**ADVICE ON ASSESSMENT - STAGE 2 WESTLINK INDUSTRIAL ESTATE
1030-1064 MAMRE ROAD AND 59-63 ABBOTTS ROAD, KEMPS CREEK**

TAB A – TfNSW advisory comments

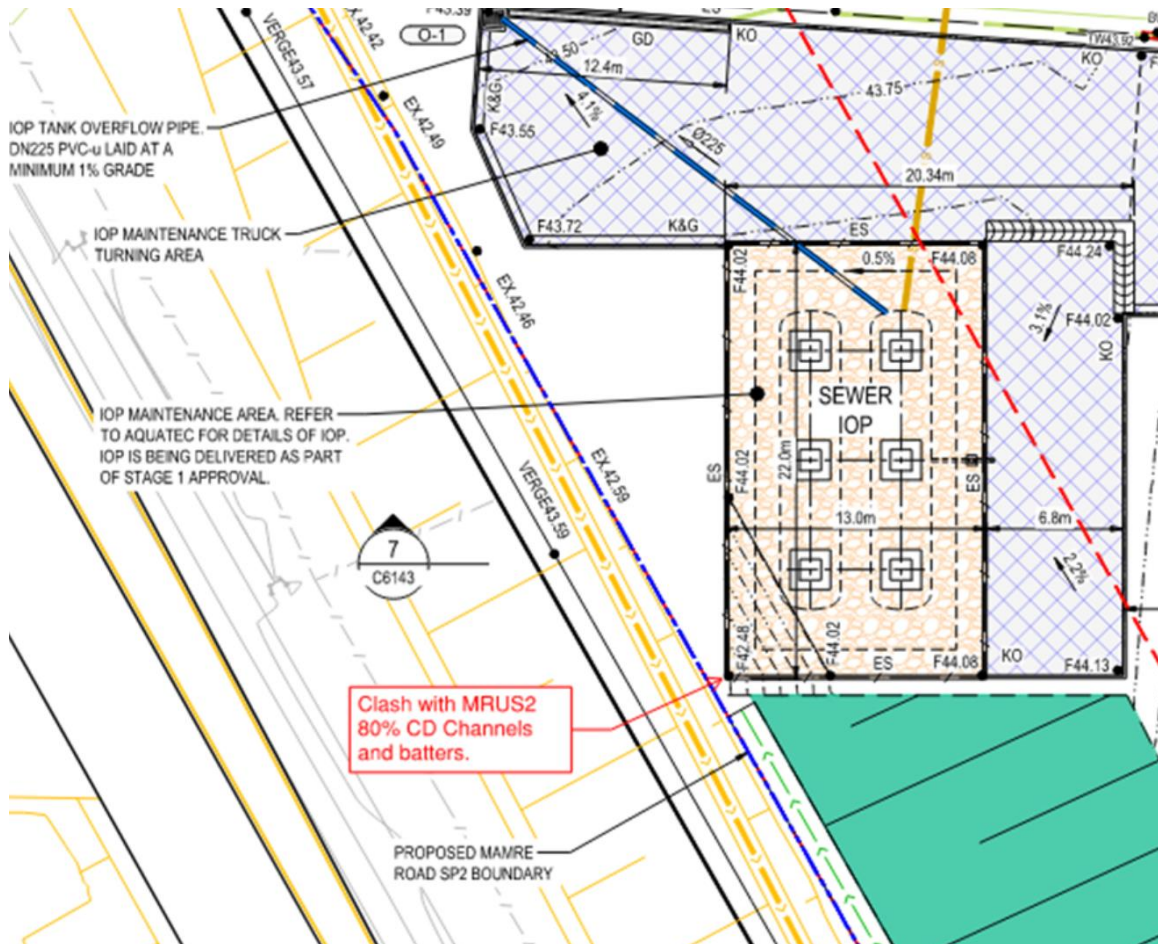
- TfNSW are generally satisfied with the tiered retaining wall or interim / future batter plans, however, raises concerns relating to the tie works to existing surface level.

- MRUS2 design assumes batters sloping back down at 4H:1V into a catch drain/swale/channel, plus additional maintenance access.
- Westlink pad for Lot 6 is higher than the proposed road level. The developer has shown in their cross sections the intention of how batters could be re-graded once MRUS2 is done. TfNSW request 3D model design from Applicant to assess.
- The channels identified on Westlink drawings look more compact than MRUS2 channels and will need to be further investigated.
- South-western corner of the Sewer IOP building will clash with the MRUS2 proposed channel and batters, noting that the developer have designed right up to the SP2 boundary at this location.

Whilst TfNSW are generally supportive of the proposal, to ensure that the design aligns with the Mamre Road Upgrade Stage 2 Project (**MRUS2**), TfNSW recommends that the Applicant engage with the MRUS2 Project Team to resolve the drainage and retaining wall issues raised above.
